Skyway Structures Contract No. 04-012024 | Oakland Touchdown 1 Contract No. 04-0120L4

CONTRACT CHANGE ORDER NO._____
SHEET _____ OF _____

DETAILS
BRIDGE STRUCTURES GIRDER EASTBOUND
SKYWAY STRUCTURES-HINGE EE

E-835

PLAN - HINGE EE

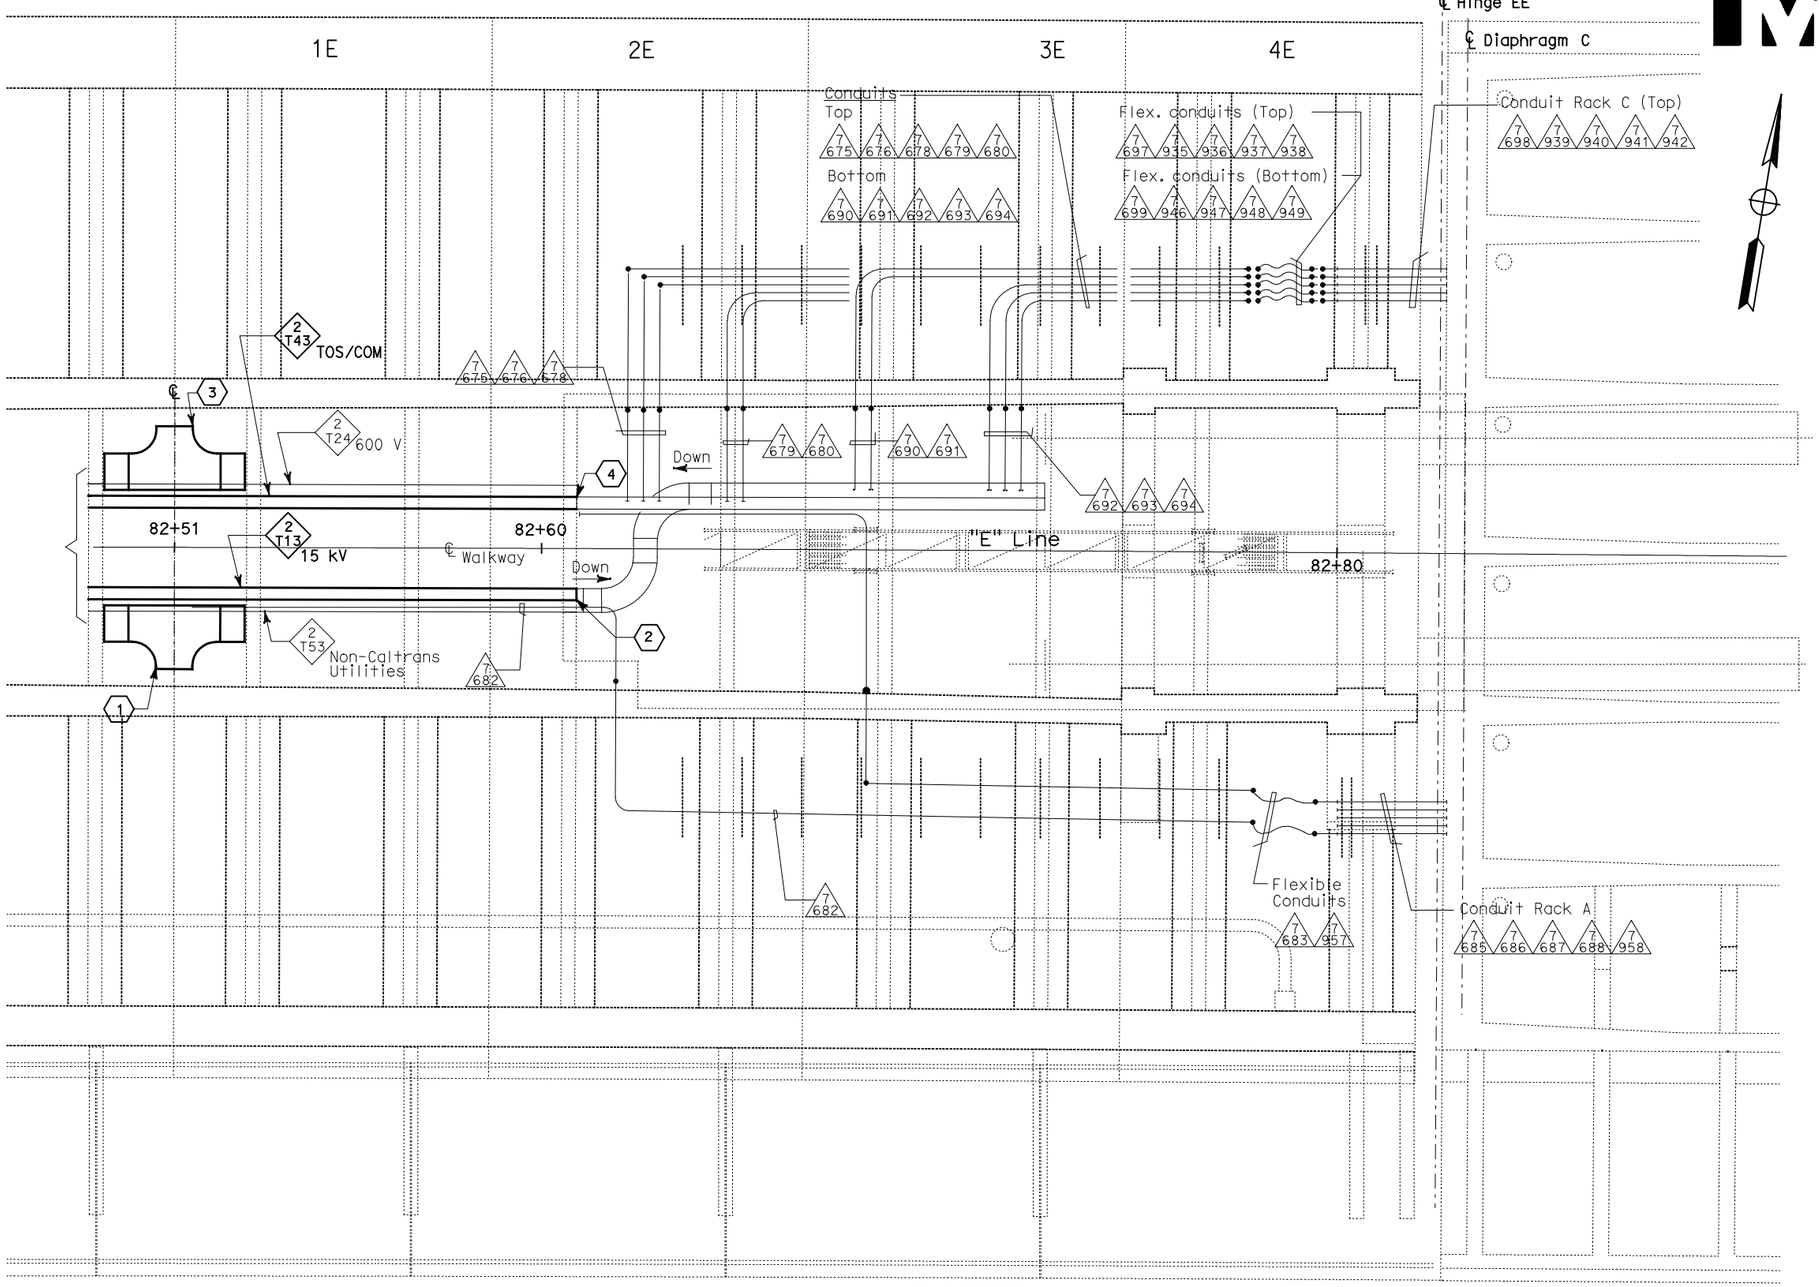
1. Furnish and install splice cable tray as shown on sheet E-836A, Detail 6.
2. Furnish and install 15 kV cables with length up to this point for splicing by others.
3. Furnish and install splice cable tray as shown on sheet E-836A, Detail 7.
4. Furnish and install fiber optic cable with length up to this point for splicing by others.
